# Staff Report

**To:** Salt Lake City Planning Commission  
**From:** Eric Daems, Senior Planner  
[eric.daems@slcgov.com](mailto:eric.daems@slcgov.com), 801-535-7236  
**Date:** June 12, 2024  
**Re:** PLNPCM2023-00890- Carrigan View Phase 2- Planned Development  
PLNSUB2024-00219- Carrigan View Phase 2- Preliminary Subdivision

## Planned Development & Preliminary Subdivision

**Buildable areas encroaching into slopes that exceed 30% (circled in blue)**

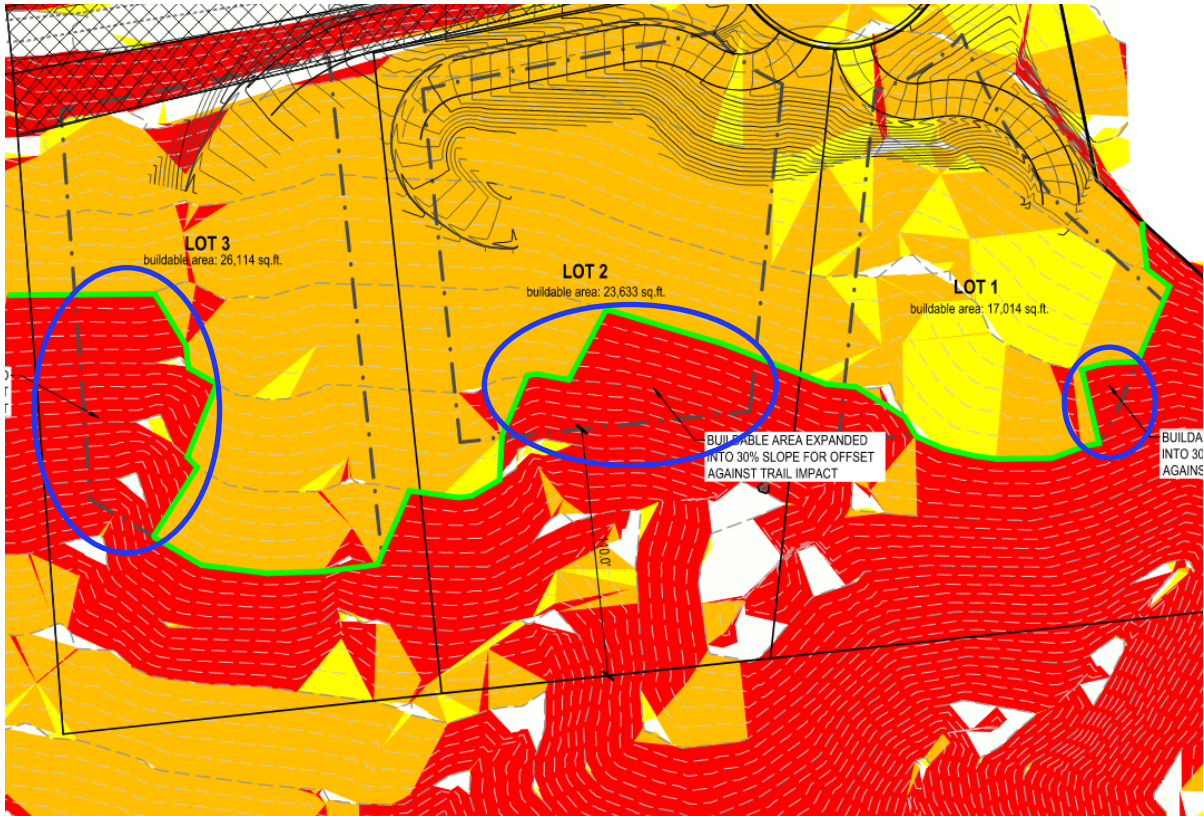
At the previous Planning Commission meeting, Staff requested additional information about the proposed buildable areas within slopes that exceed 30%. The applicant has provided revised drawings to show the amount of land within each steep slope area and lot slope profiles showing a cross section of each proposed lot. A breakdown of proposed buildable areas within the steep slope areas and the lot slope profiles are shown below.

Due to the large buildable areas of the lots and potential impacts created, Staff does not recommend portions of the buildable areas to exceed 30% slope. If the Planning Commission votes to approve the buildable areas within the steep slope area, Staff is recommending that a geotechnical evaluation be conducted and the recommendations therein be implemented.

After weighing these considerations, Staff is recommending denial of the buildable areas exceeding a 30% slope. The properties still have large buildable areas to accommodate development in harmony with the neighborhood. Lot 1 would have a buildable area of approximately 16,000 sq. ft, Lot 2 would have close 17,000 sq. ft., and Lot 3 would have near 18,000 sq. ft.. The Planning Division concludes that it is important to retain the 30% undevelopable slope prohibition and that the applicant has not provided any information to warrant setting a precedent of allowing development within a steep slope area.

**20' Public Access Easement Alignment**

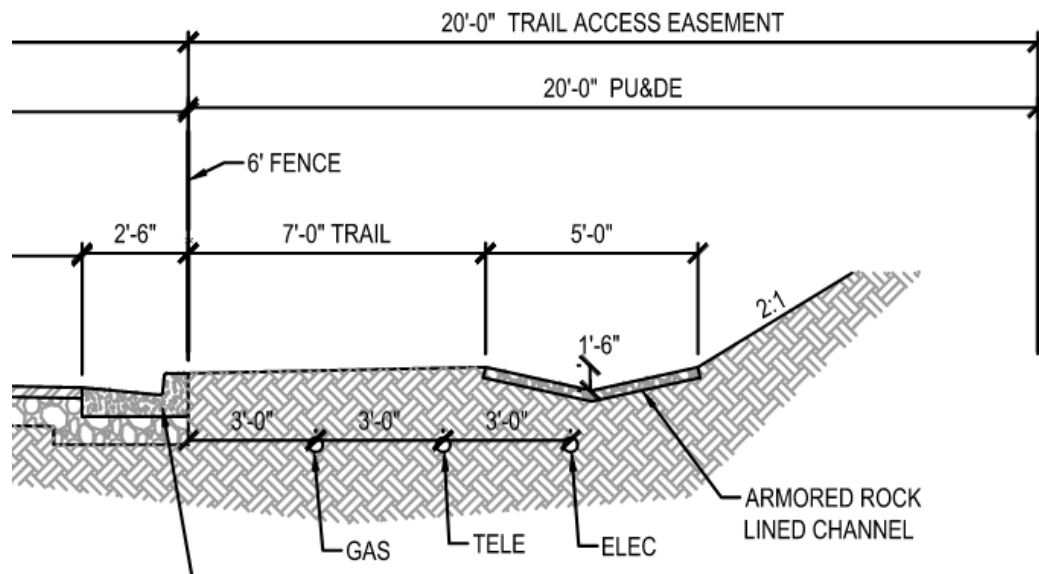
Since the previous Planning Commission meeting, Staff was made aware of an annexation agreement for the Carrigan View Phase 1 subdivision. That agreement includes a condition that a 20' wide public access easement be included from Lakeline Drive towards the H-Rock, generally following the public utility easement for the waterline.

The proposed trail placement with this development would align with that agreement and Staff is recommending a public access easement be recorded with the plat. The trail alignment described in the annexation agreement is shown below.

1. A 20' wide public access easement be dedicated from the property line at Lakeline Drive towards the H-Rock, generally located in alignment with the public utility easement for the waterline.

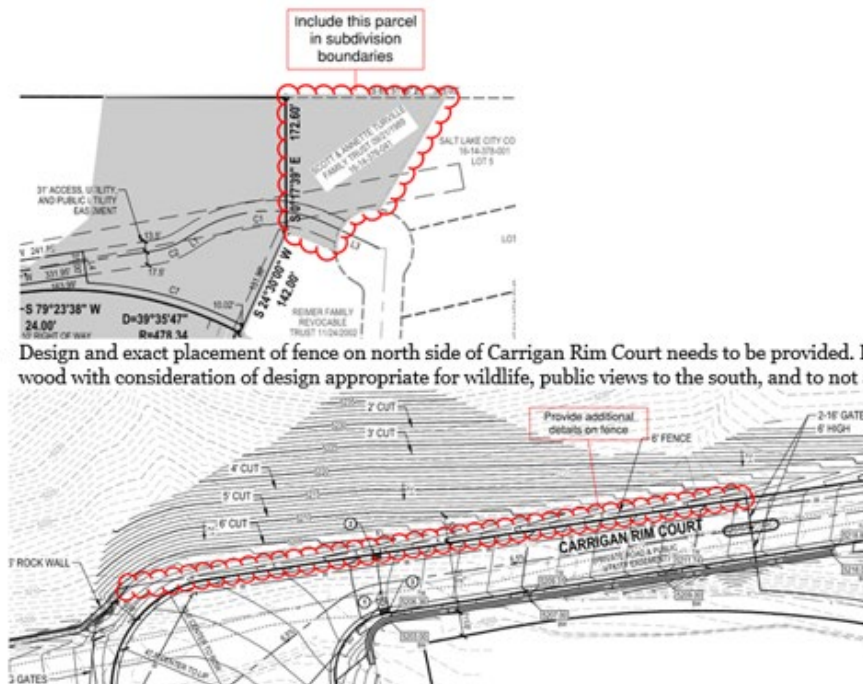
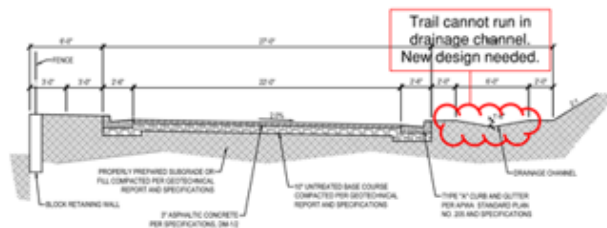
- Design and exact placement of fence on north side of Carrigan Rim Court needs to be provided. Fence should be metal or wood with consideration of design appropriate for wildlife, public views to the south, and to not attract graffiti.

- Trail cannot run through drainage channel as it would cause substantial rutting and other problems. With the private road removing the existing trail, this needs to be engineered in an acceptable manner for an at least 6' trail to function. The premise of the Planned Development is to create a public benefit, so this element is critical to solve. As drawn, it is more of a private benefit to handle the drainage for the private development. Trail surface needs to have a convex crown.

- The proposed 5' retaining wall will need to be engineered for building permit review
- Revised cut and fill plan should be sought (see notes from Jena)
